RE: EPC SF2219 – Mayberry Filing 3 Drainage Report Comment Response

FINAL DRAINAGE REPORT

MAYBERRY, COLORADO SPRINGS – FILING NO. 3

SHEET: **EX2**

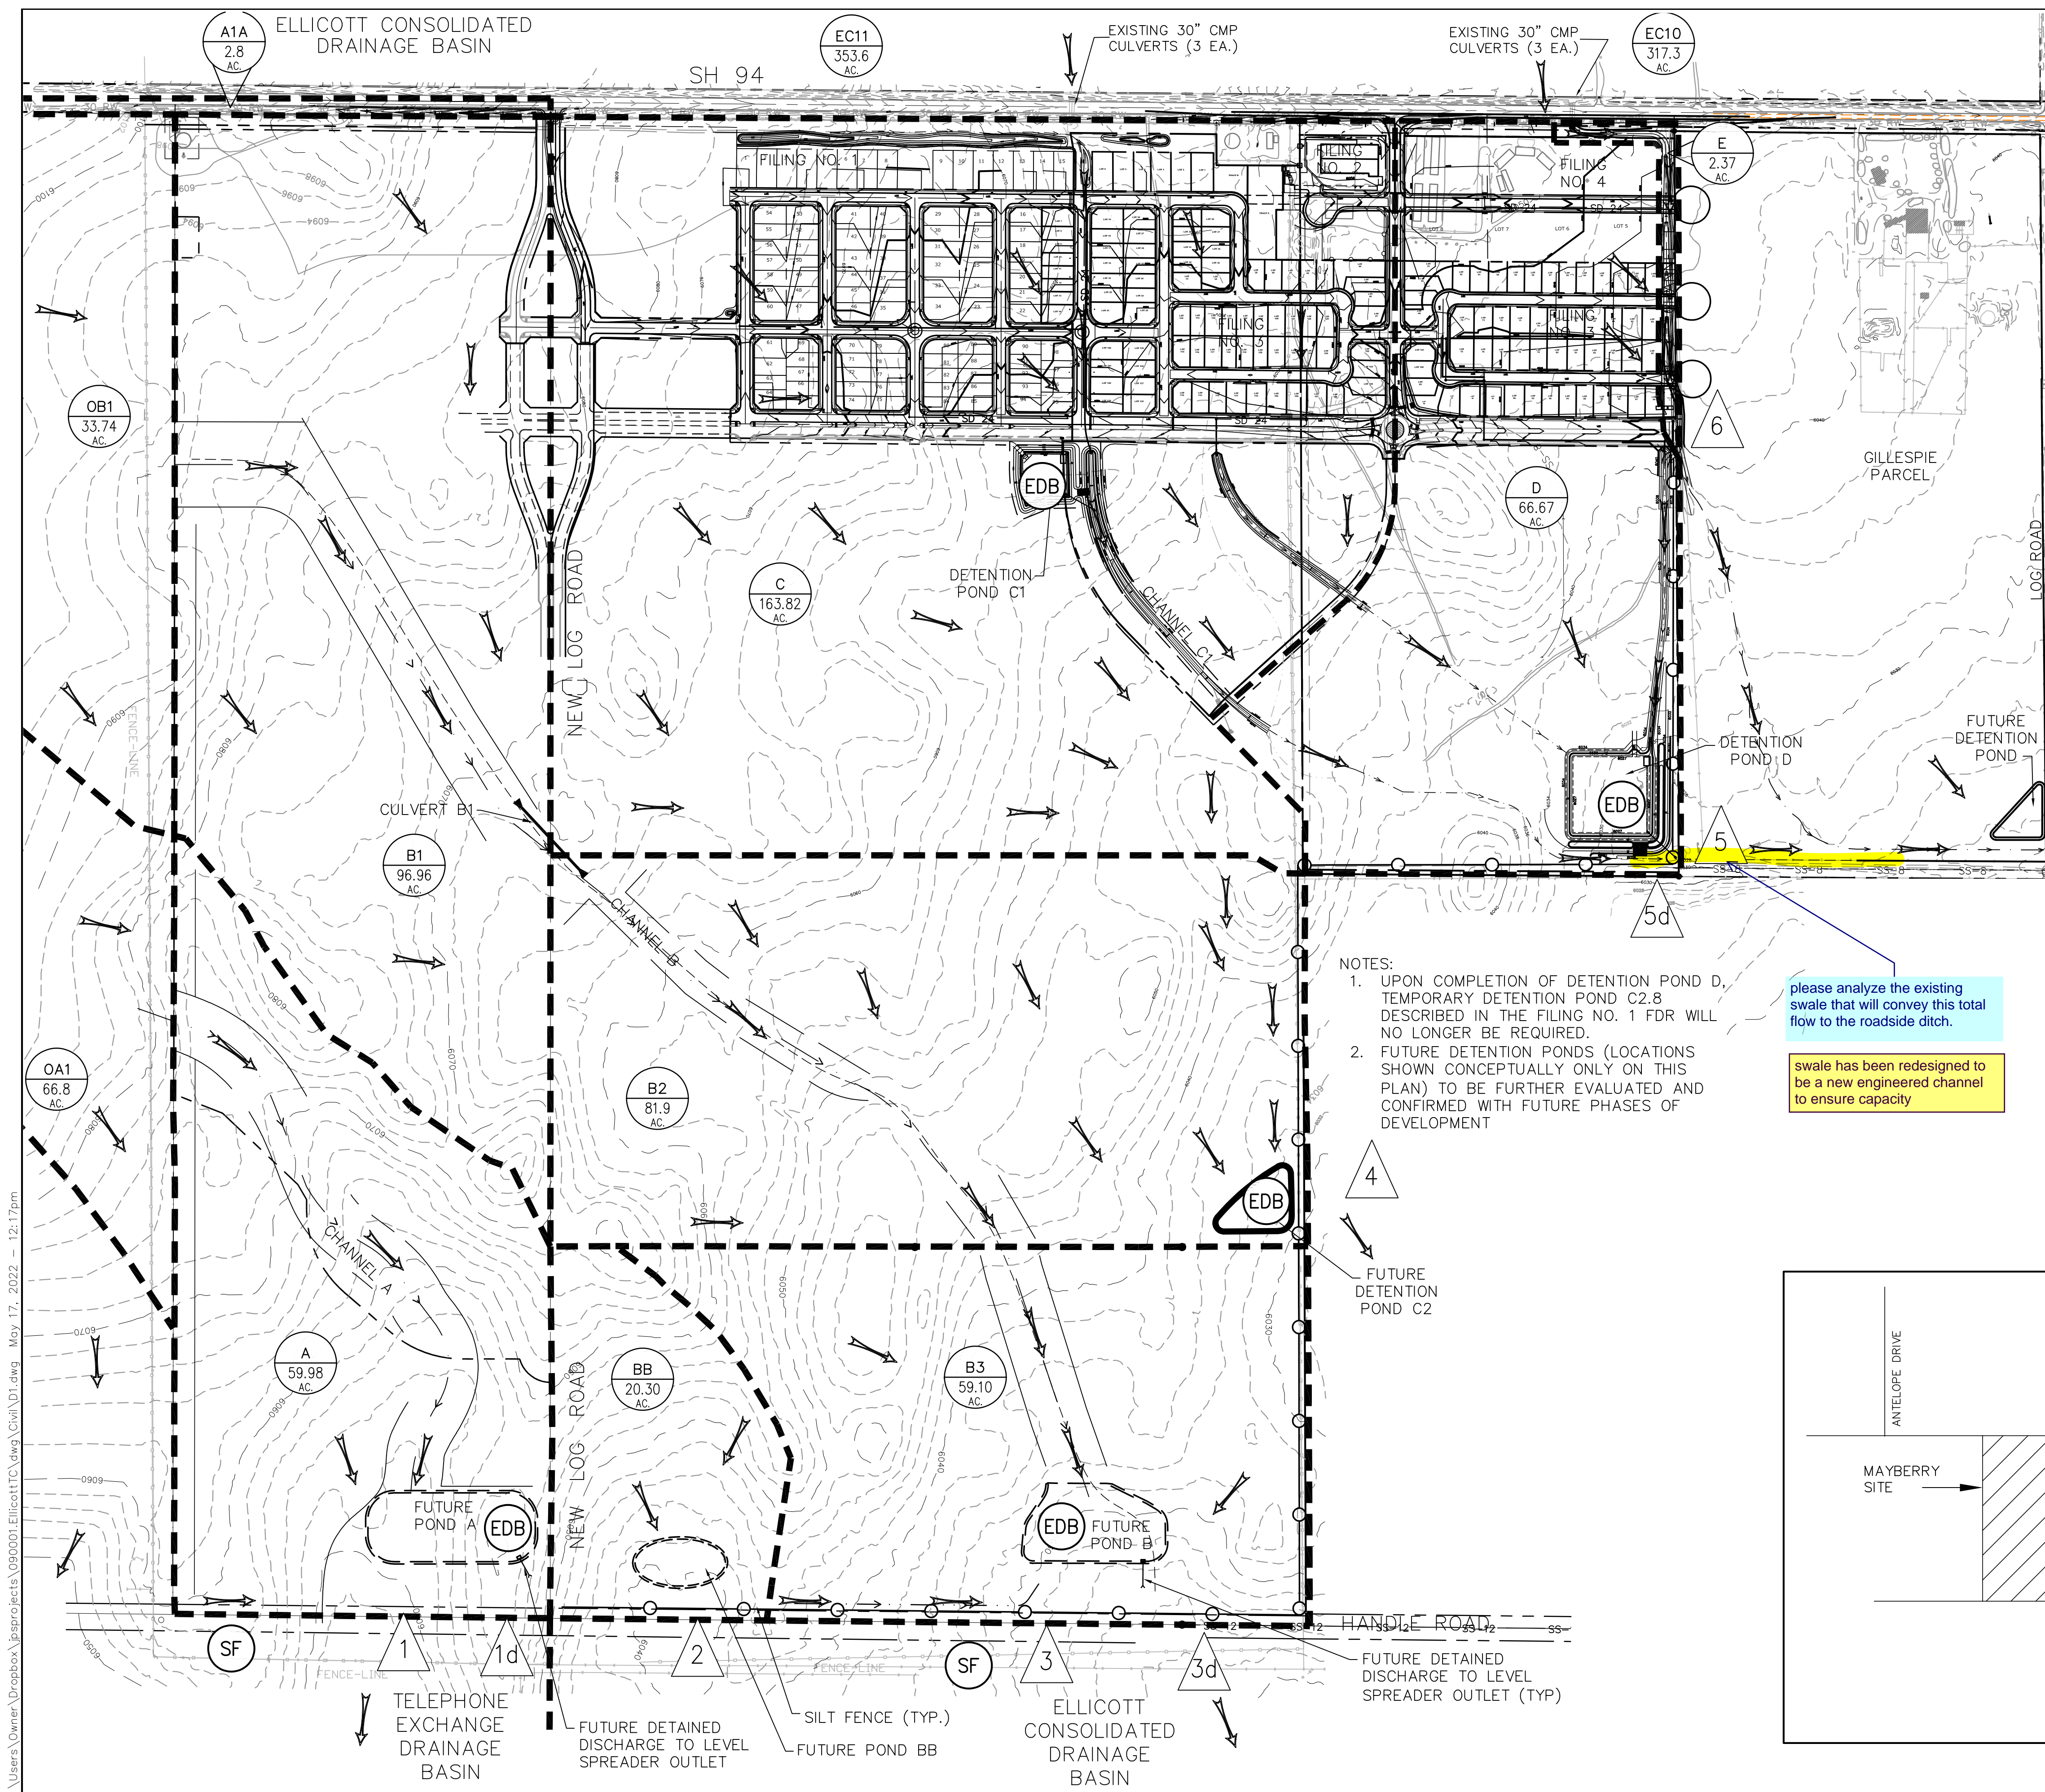
Please clarify/elaborate regarding the outfall of Basin D. Per the existing drainage map the flow turns east into the Gillespie parcel at the southeast corner of the site due to a berm at this location. A comment has been provided on the drainage map to show the appropriate flow arrow on the map.

the outfall has been revised to convey water through a defined channel as opposed to the previous design

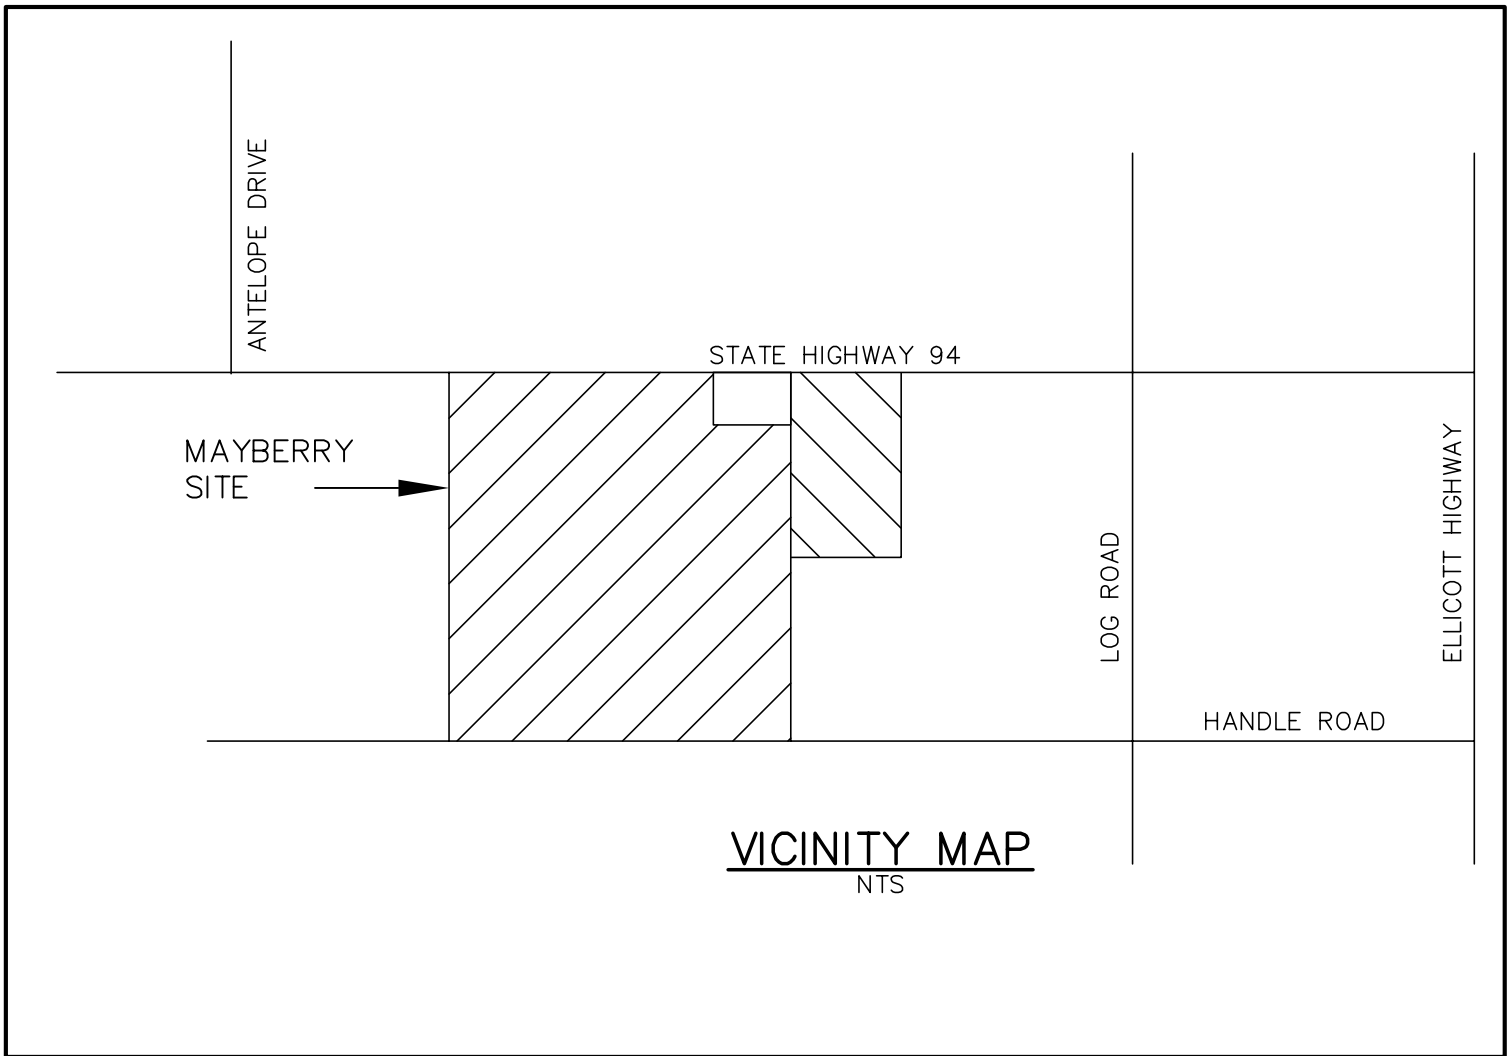
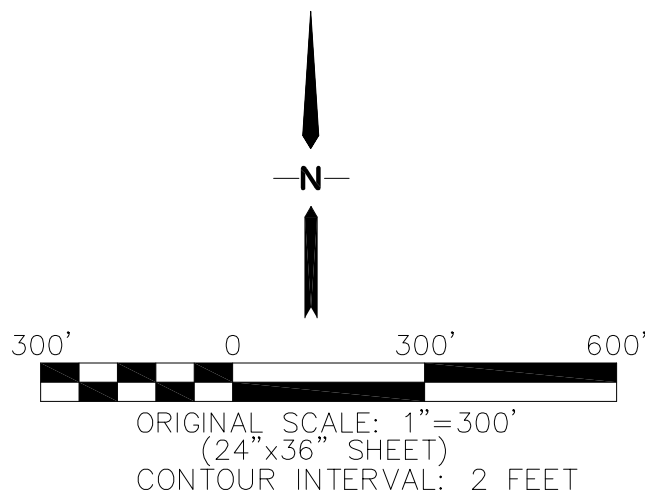
please analyze the existing swale that will convey this total flow to the roadside ditch.

swale has been redesigned to be a new engineered channel to ensure capacity
